**WASILLA PLANNING COMMISSION
RESOLUTION SERIAL NO. 14-09(AM)**

A RESOLUTION OF THE WASILLA PLANNING COMMISSION APPROVING CONDITIONAL USE PERMIT NUMBER CU 14-03 TO CONSTRUCT A 6,000 SQUARE FOOT COMMERCIAL BUILDING ON A LOT WITH 9,268 EXISTING COMMERCIAL SQUARE FOOTAGE (PIZZA HUT & MIDAS), LOCATED ON LOT A19, TOWNSHIP 17N, RANGE 1W, SECTION 10, IN THE COMMERCIAL ZONING DISTRICT.

Lake Side Plaza
Building B

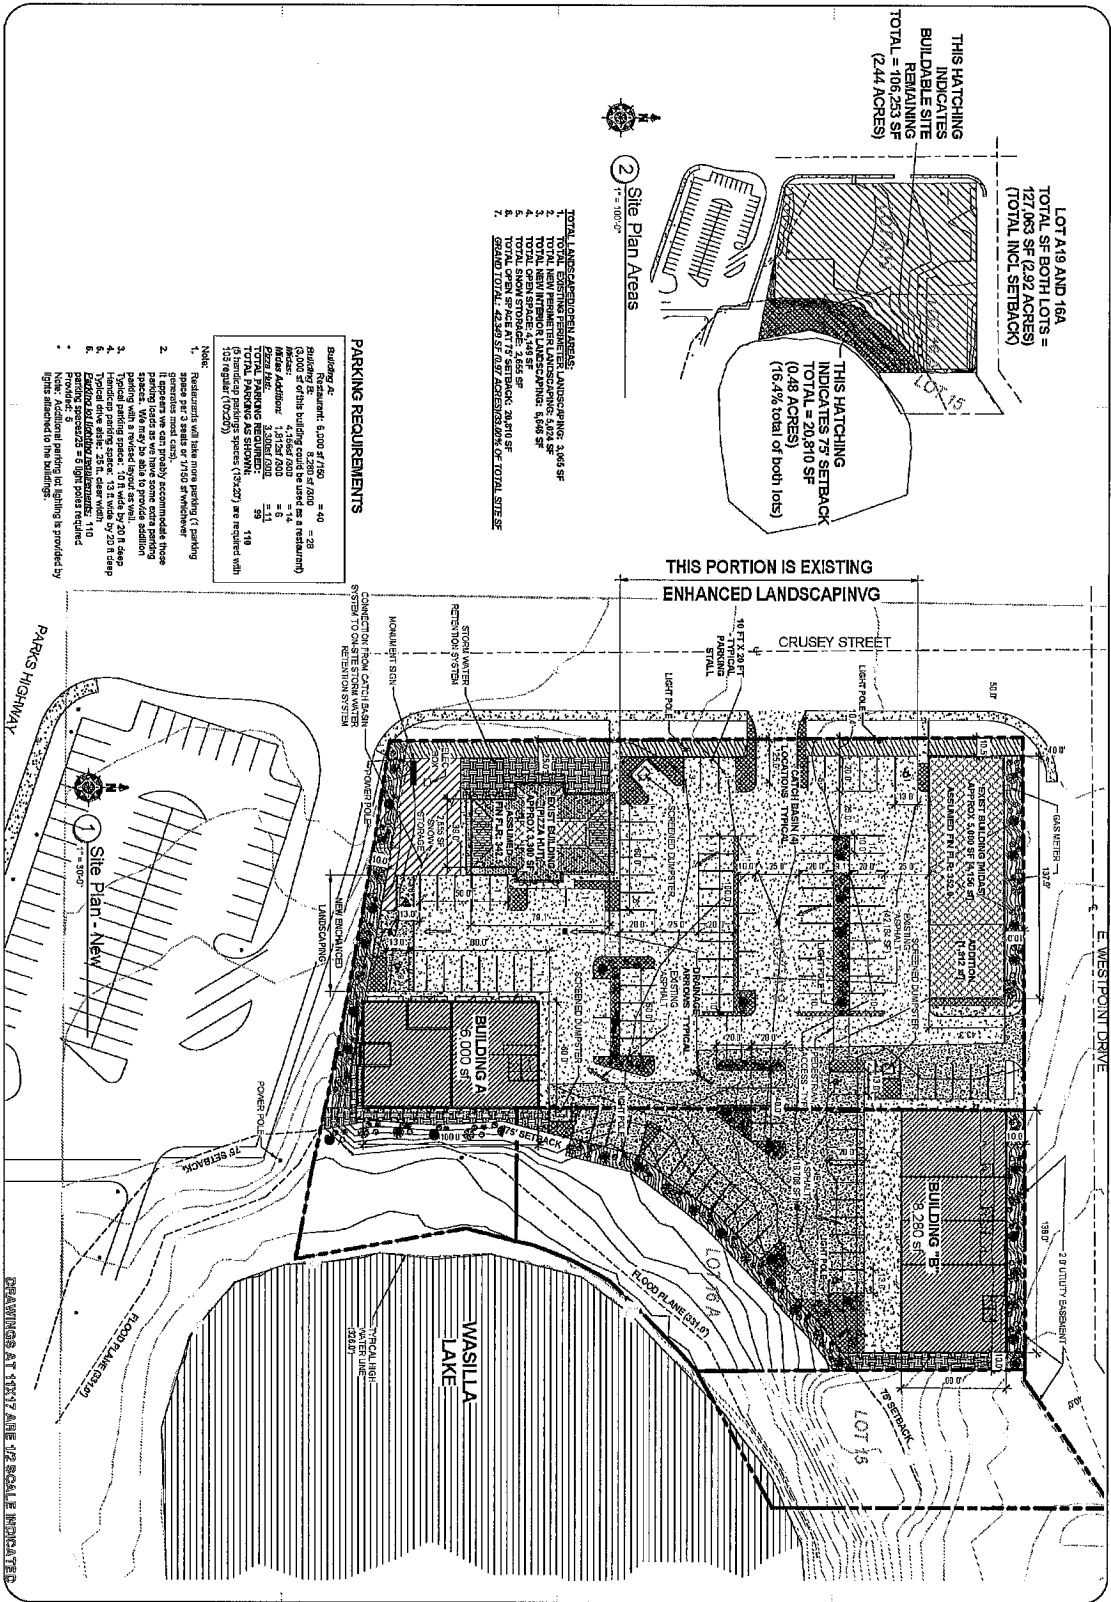
4. A sidewalk must be constructed along the entire length of the subject property abutting E. Westpoint Drive and must connect into the existing sidewalk at the intersection of Crusey Street and E. Westpoint Drive. Additionally, the new sidewalk must connect to the sidewalk proposed along the western edge of Building "B" on the site plan in Exhibit B.

Finding: The attached site plan submitted by the applicant complies with the minimum setbacks and maximum height requirements of §16.24.010 with the exception of a very small portion of the rear setback along the property line abutting Lot 16A (see site plan for details.) The applicant has submitted a variance application requesting a variance of 25 feet to the required 25 foot setback in this area. With approval of the variance, this criterion is met.

Finding: The attached site plan indicates 110 paved parking spaces, adequate paved aisle widths, and the applicant adequate snow storage on the site.

5. Construction on the site must substantially comply with the site plan and landscape plans date stamped April 21, 2014, attached as Exhibit B to Resolution Serial No. 14-09. Any changes to the site plan must be submitted to the City Planner for review. Substantial modifications will require submittal of an
